**WHITESTONE**  
solar farm

# Targeted Consultation Leaflet

4 March – 3 April 2026

## **We are now carrying out an additional, targeted consultation on proposed changes to the boundary of Whitestone Solar Farm, known as the ‘draft order limits’.**

# Change 1: Cable Route West of Micklebring

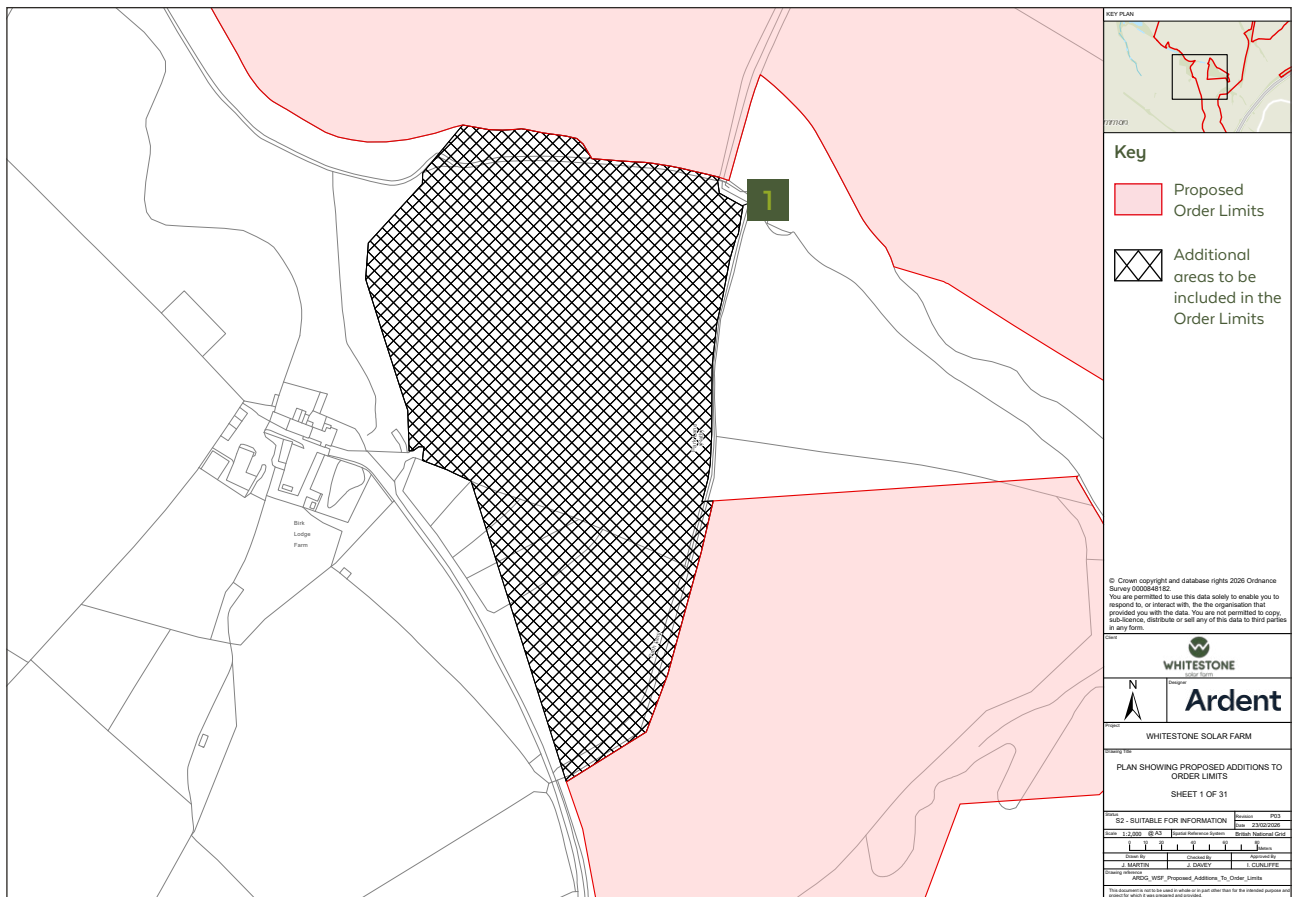
**Description of Change:** Additional land west of Micklebring and the M18 is under consideration as an alternative cable route option for Cable Route B to avoid cabling to the east of Micklebring Gorse, pending finalisation of environmental and engineering surveys on both locations. This does not add an additional cable route but provides an alternative option for the already proposed cable route between Whitestone 1 and 2.

**Impact of Change:** This change is not anticipated to result in any impacts that are not already being considered within the EIA being undertaken to support the Proposed Development. This change may cause temporary impacts on Public Rights of Way (Conisbrough Parks 4 and 15). The Applicant will seek to ensure access is maintained and any disturbance is short term. Any noise generated during construction of the cable corridor is already being assessed in the EIA and industry best practice mitigation will minimise any short-term disturbance on nearby receptors. Construction work will be managed in a way to minimise any disturbance on receptors through an Outline Public Rights of Way Management Plan and an Outline Construction Environmental Management Plan. This change is unlikely to lead to significant adverse effects.

## Change 2: Landscaping on the M18

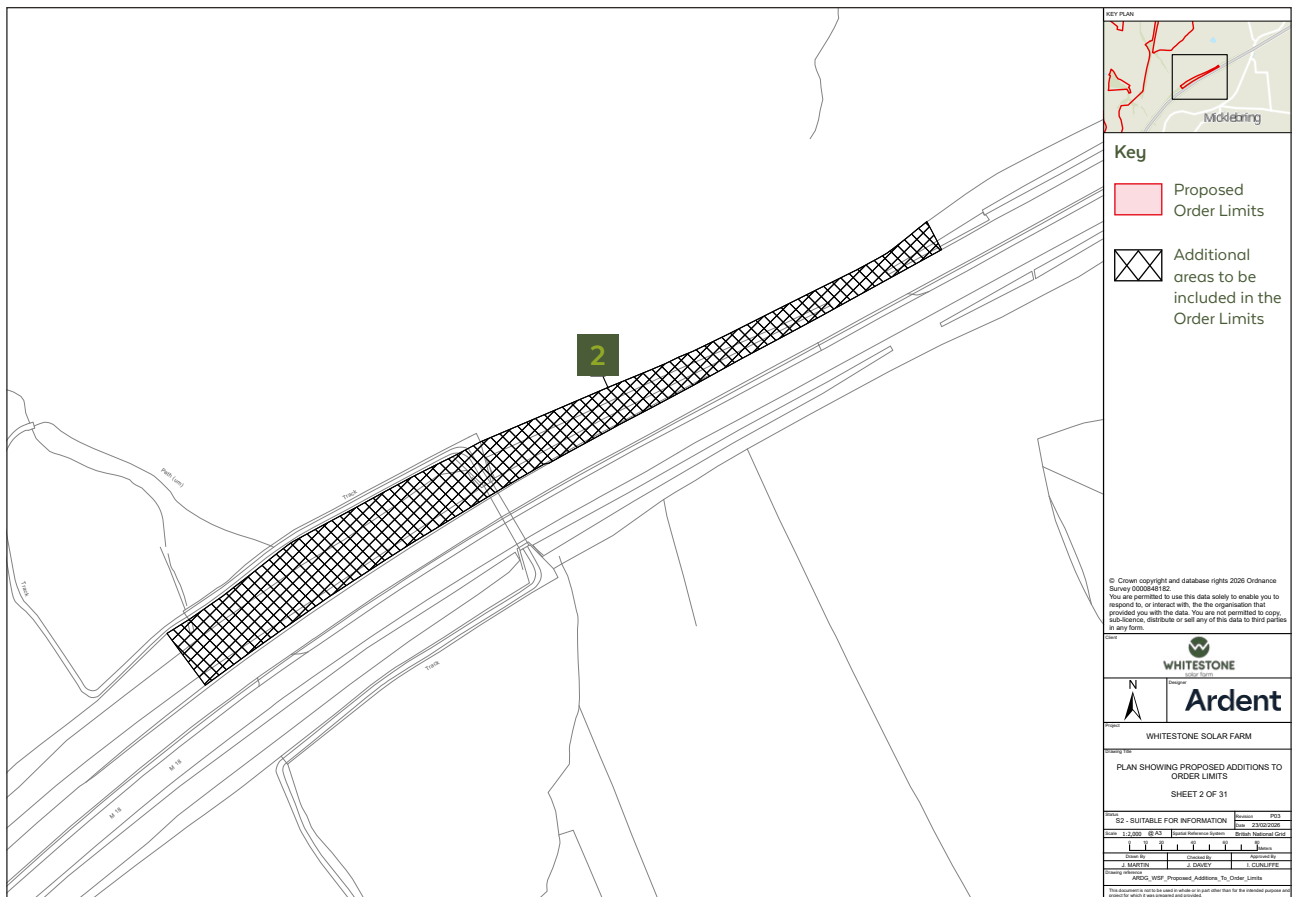
**Description of Change:** Additional land is proposed along the M18 and north of Micklebriug for landscaping to minimise potential glint and glare impacts on the adjacent road. Works could include the planting of trees, hedges or other landscaping and visual barriers as needed.

**Impact of Change:** The impact is dependent on type of visual screening. There is a preference for planting of hedgerows and trees which would have beneficial impacts on habitat creation and connectivity. It may be necessary to install temporary fencing whilst vegetation establishes, however it is expected that any adverse impact would be not significant as receptors would be driving and views impacted would be fleeting.

# Change 6: Road Safety and Cable Route North of Morthen

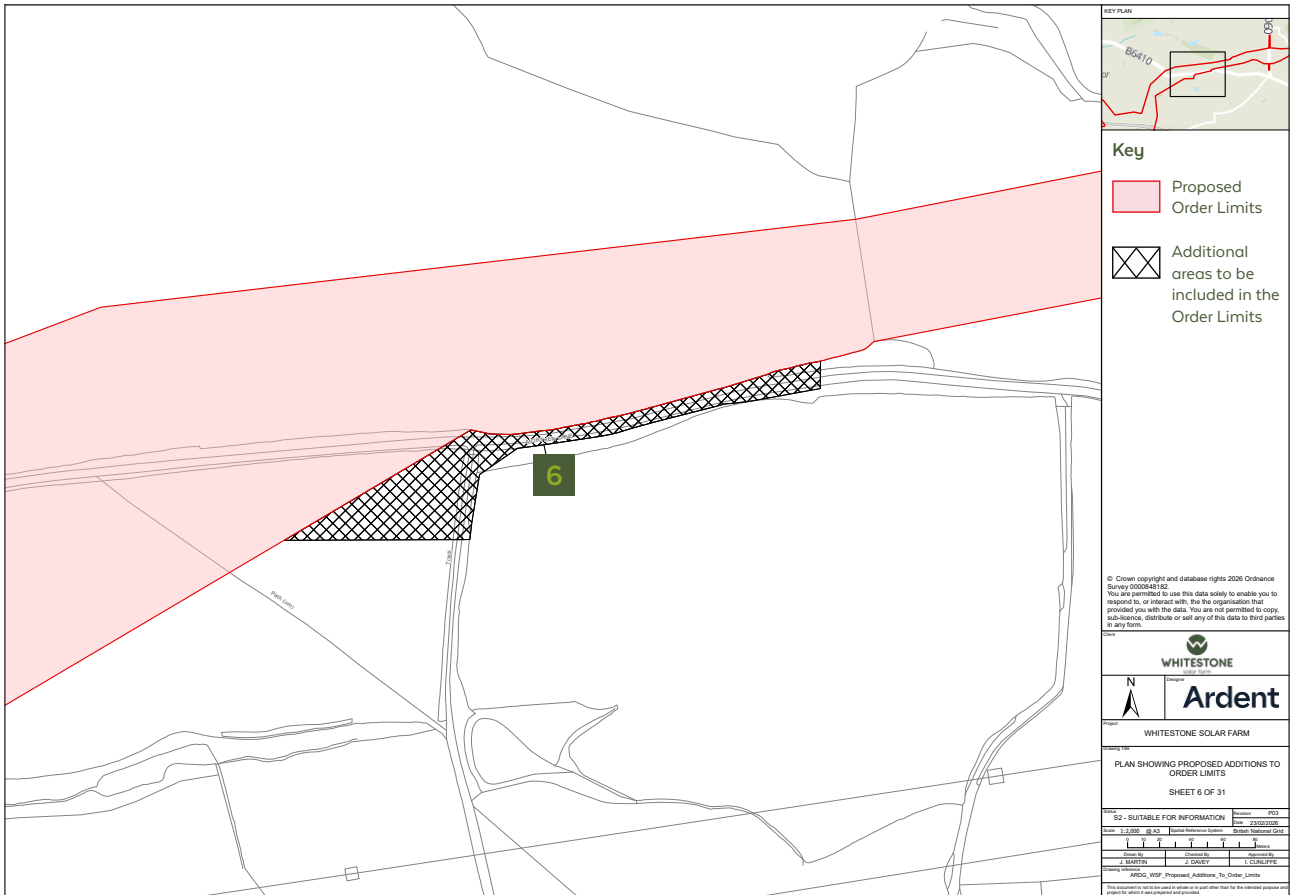
**Description of Change:** Additional land is proposed along Morthen Lane, north of Morthen, to allow the proposed access to Cable Route C, to comply with highway safety standards for visibility and temporary speed limits during construction if required. The works could include trimming hedges or roadside vegetation for safe visibility, temporary road signage for managing safe access and temporary speed limits during construction.

**Impact of Change:** This change may lead to the loss of hedgerow and roadside vegetation. This impact is already being considered within the EIA being undertaken to support the Proposed Development. The Proposed Development will include commitments to planting new hedgerows and creation of additional areas of habitat including safeguarding of any species as needed. With suitable mitigation, this change is unlikely to lead to significant adverse effects.

## Change 7: Road Safety South of Whiston

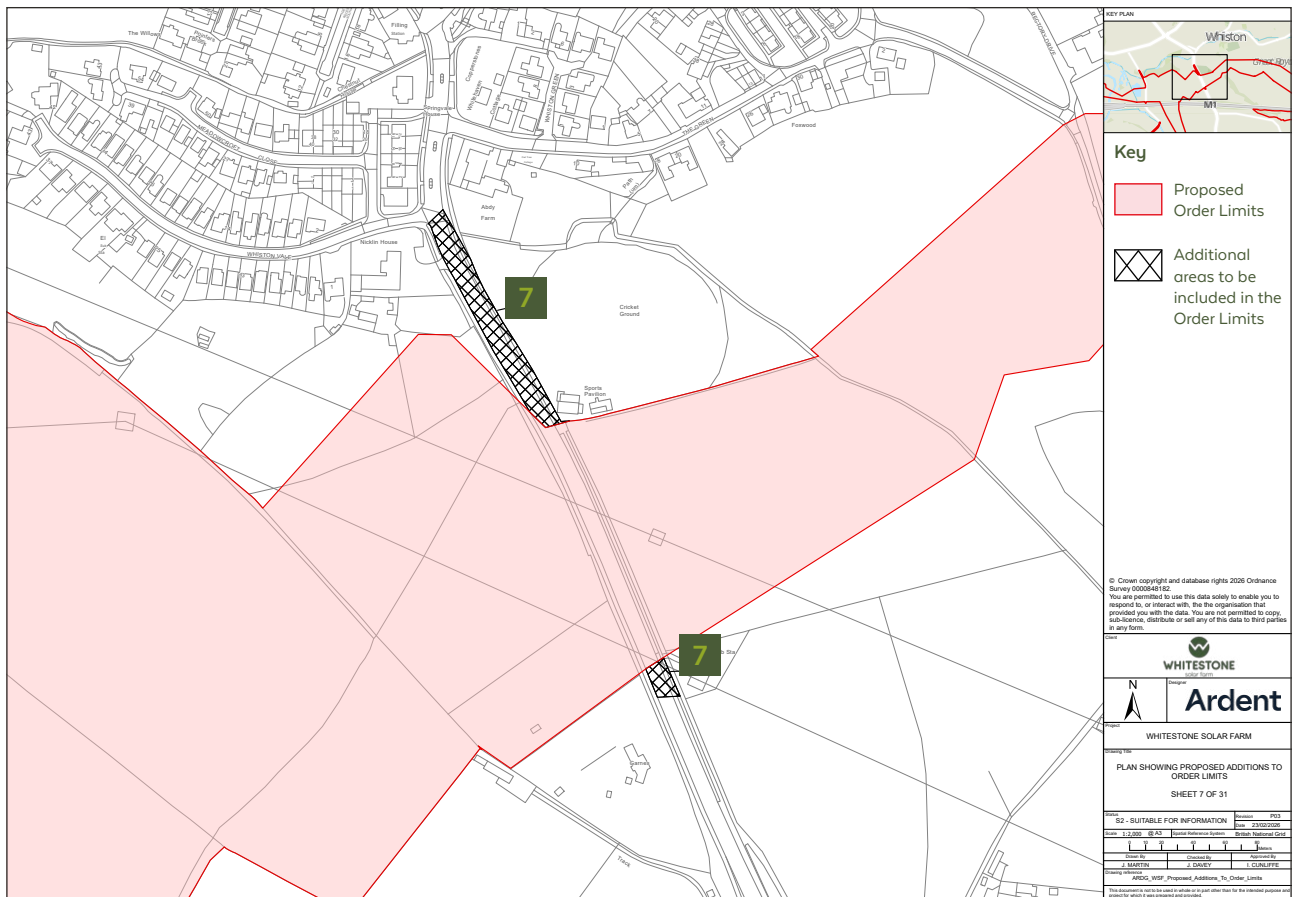
**Description of Change:** Additional land is proposed along Pleasley Road (A618) south of Whiston to allow the proposed access to Cable Route D-1, to comply with highway safety standards for visibility and temporary speed limits for construction if required. The works could include trimming hedges or roadside vegetation for safe visibility, temporary road signage for managing safe access and temporary speed limits during construction.

**Impact of Change:** This change may lead to the loss of hedgerow and roadside vegetation. This impact is already being considered within the EIA being undertaken to support the Proposed Development. The Proposed Development will include commitments to planting new hedgerows and creation of additional areas of habitat including safeguarding of any species as needed. With suitable mitigation, this change is unlikely to lead to significant adverse effects.

## Change 8: Road Safety South of Whiston

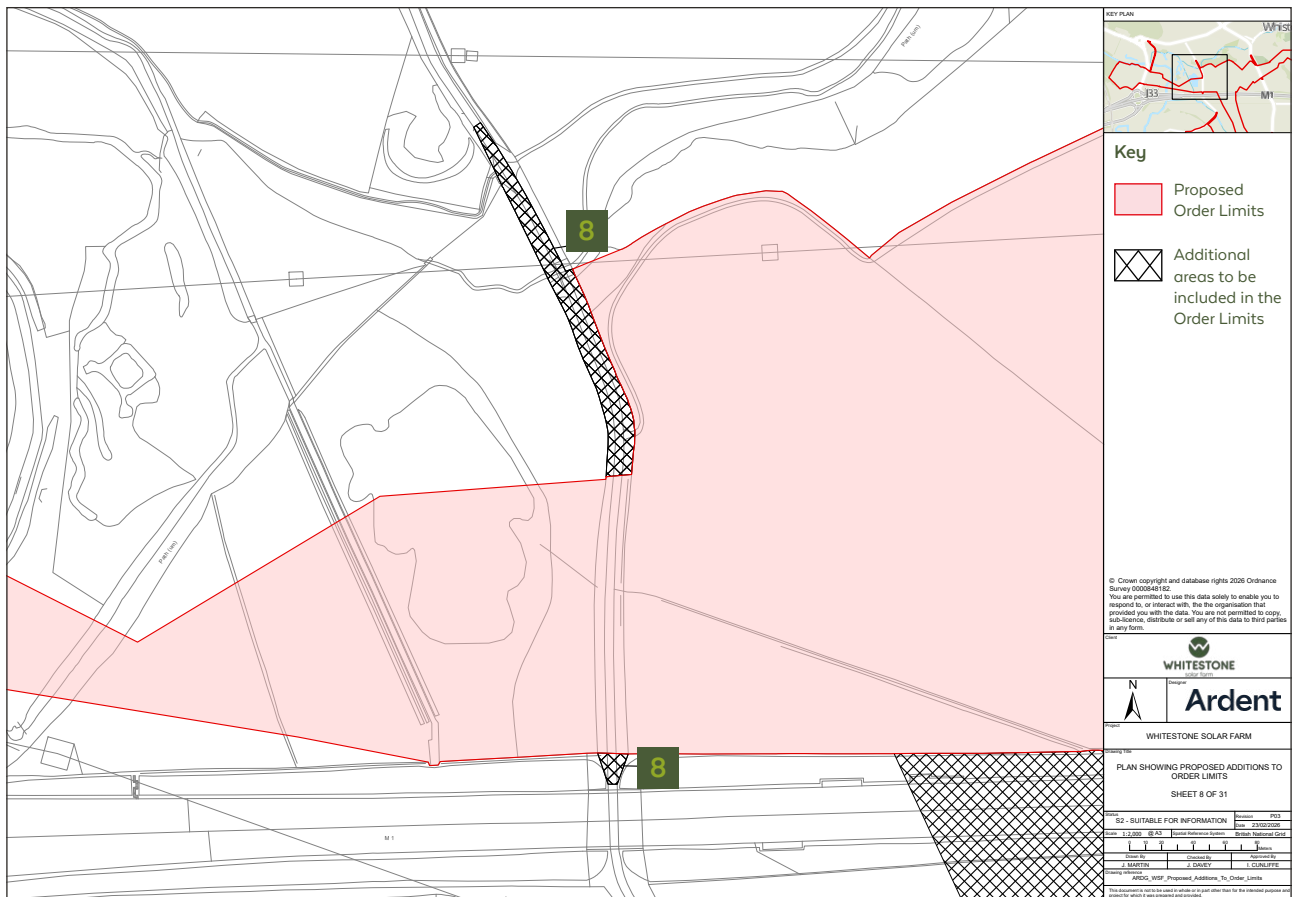
**Description of Change:** Additional land is proposed along Long Lane southwest of Whiston to allow the proposed access to Cable Route E, to comply with highway safety standards for visibility and temporary speed reductions if required.

**Impact of Change:** This change may lead to the loss of hedgerow and roadside vegetation. This impact is already being considered within the EIA being undertaken to support the Proposed Development. The Proposed Development will include commitments to planting new hedgerows and creation of additional areas of habitat including safeguarding of any species as needed. With suitable mitigation, this change is unlikely to lead to significant adverse effects.

## Change 9: Cable Route at Brinsworth

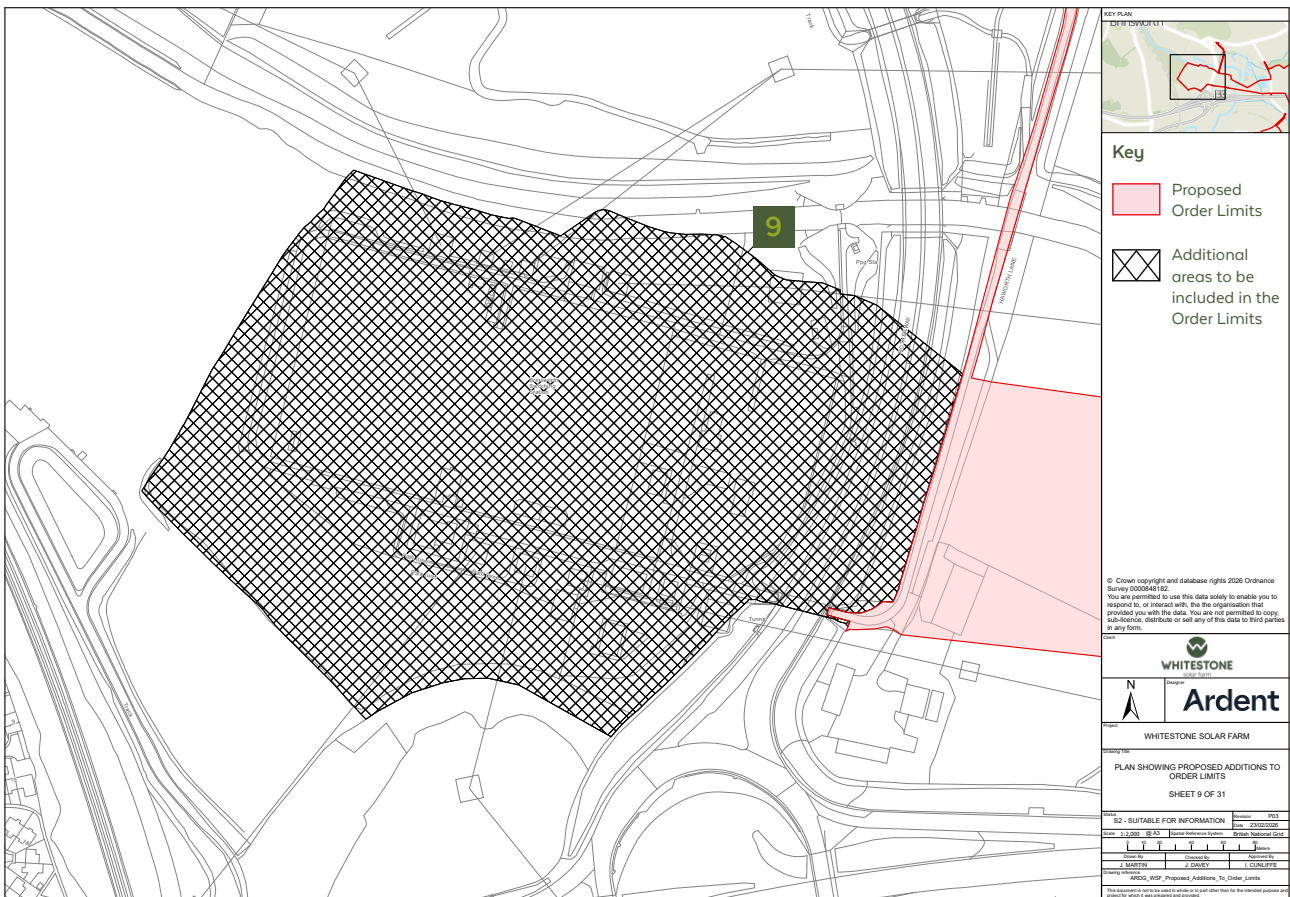
**Description of Change:** While the grid connection is to the Long Lane 400kV Substation, the Applicant notes that this substation is still in planning and has not yet been constructed. Therefore, additional land is being proposed to connect into the existing Brinsworth substation if for any reason the new Long Lane 400kV Substation is not constructed. Works would include underground cabling to the substation.

**Impact of Change:** As the change consists of running an underground cable, the potential effects could be flood risk, cultural heritage and land and soils due to a high risk from coal mining. These constraints would need to be fully assessed and construction work would be managed to limit and mitigate potential impacts.

# Change 11: Road Safety Northeast of Treeton

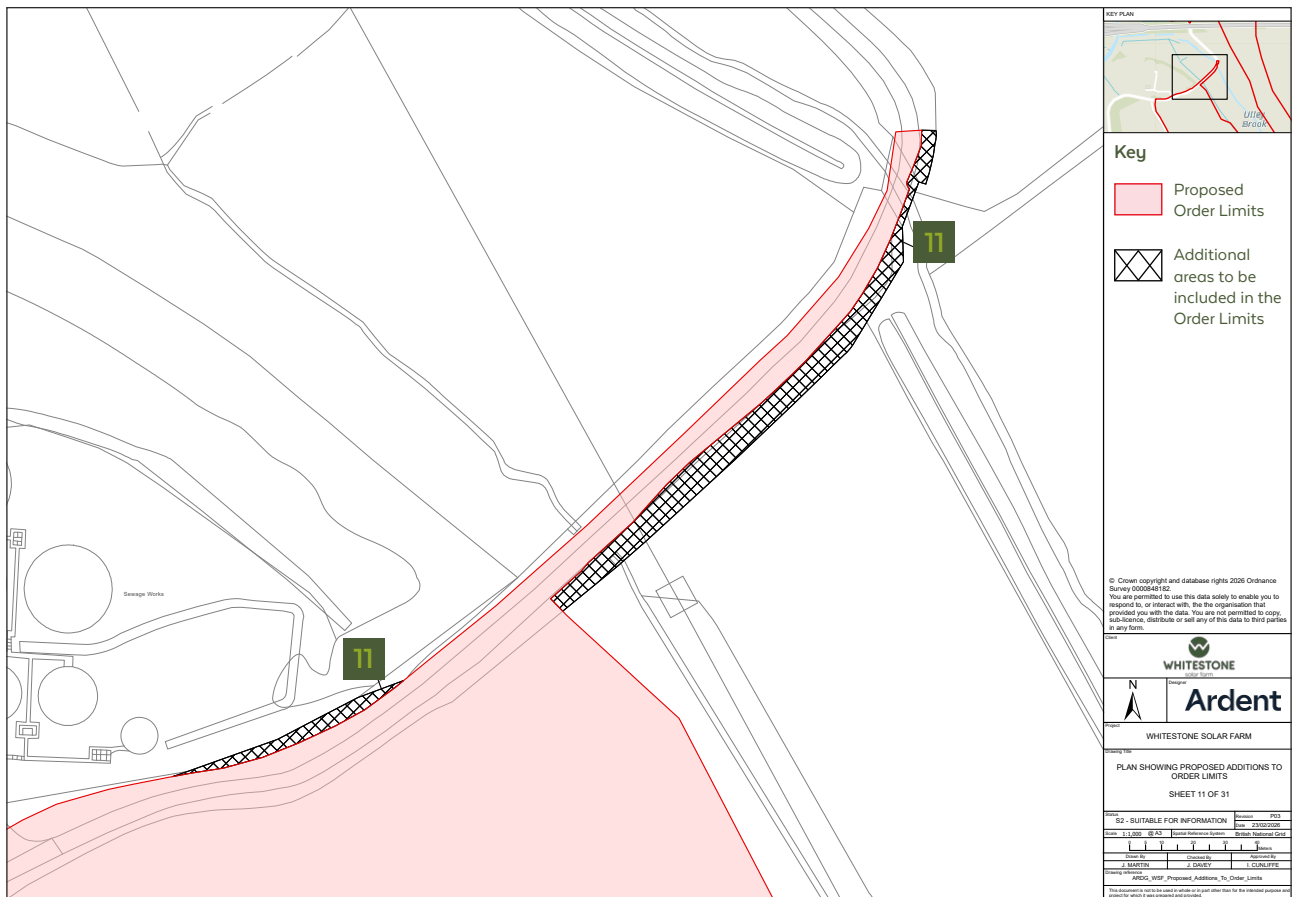
**Description of Change:** Additional land is proposed along Long Lane northeast of Treeton to allow the proposed access to solar area to comply with highway safety standards for visibility and temporary speed limits if required. The works could include trimming hedges or roadside vegetation for safe visibility, temporary road signage for managing safe access and temporary speed limits during construction if required.

**Impact of Change:** This change may lead to the loss of hedgerow and roadside vegetation if other mitigations such as temporary speed limits are not feasible. This impact is already being considered within the EIA being undertaken to support the Proposed Development. The Proposed Development will include commitments to planting new hedgerows and creation of additional areas of habitat including safeguarding of any species as needed. With suitable mitigation, this change is unlikely to lead to significant adverse effects.

## Change 12: Road Safety Northeast of Treeton

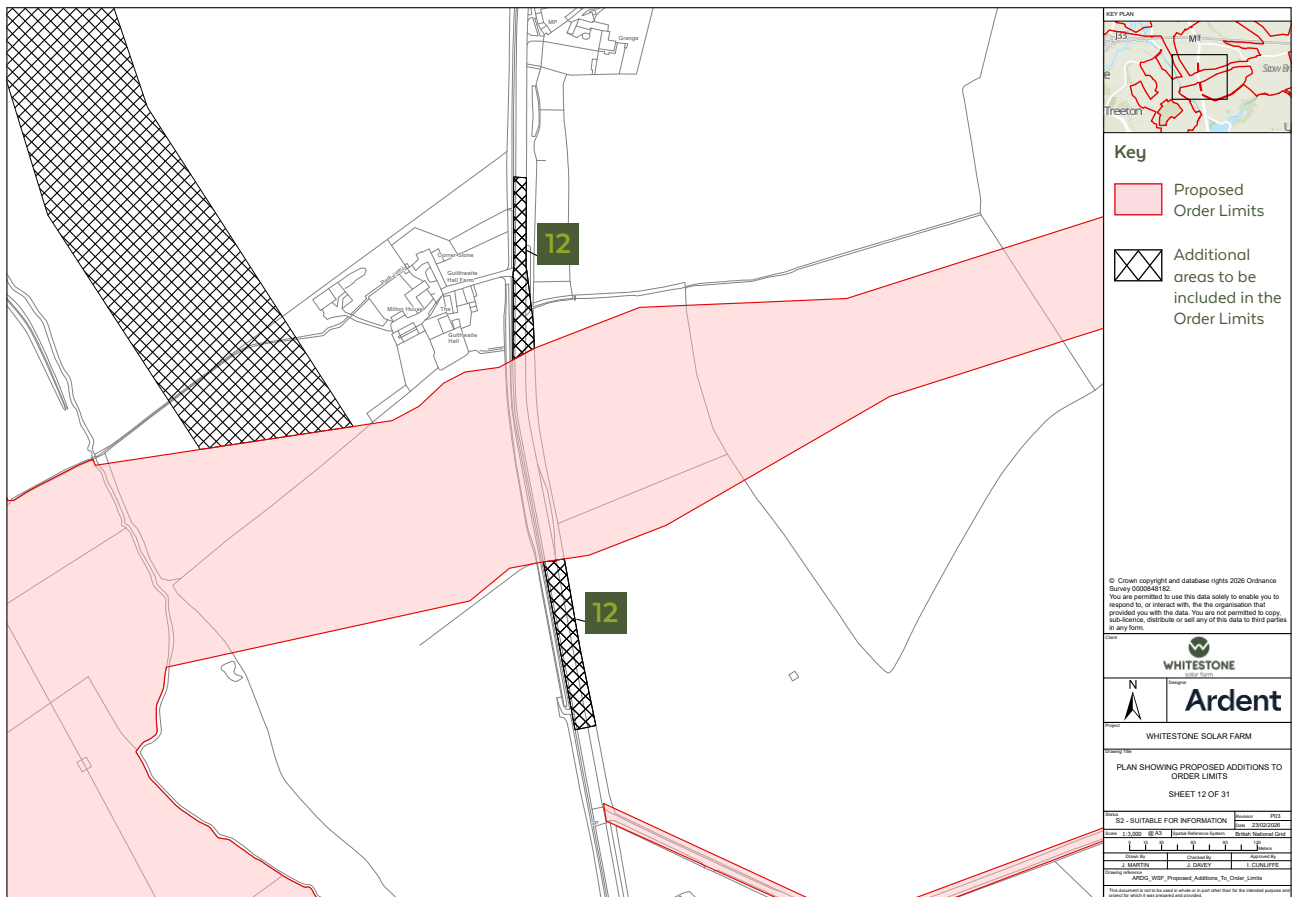
**Description of Change:** Additional land is proposed along Pleasley Road (A618) to allow the proposed access to Cable Route F, to comply with highway safety standards for visibility and temporary speed limits if required. The works could include trimming hedges or roadside vegetation for safe visibility, temporary road signage for managing safe access and temporary speed limits during construction if required.

**Impact of Change:** This change may lead to the loss of hedgerow and roadside vegetation if other mitigations such as temporary speed limits are not feasible. This impact is already being considered with the EIA being undertaken to support the Proposed Development. The Proposed Development will include commitments to planting new hedgerows and creation of additional areas of habitat including safeguarding of any species as needed. With suitable mitigation, this change is unlikely to lead to significant adverse effects.
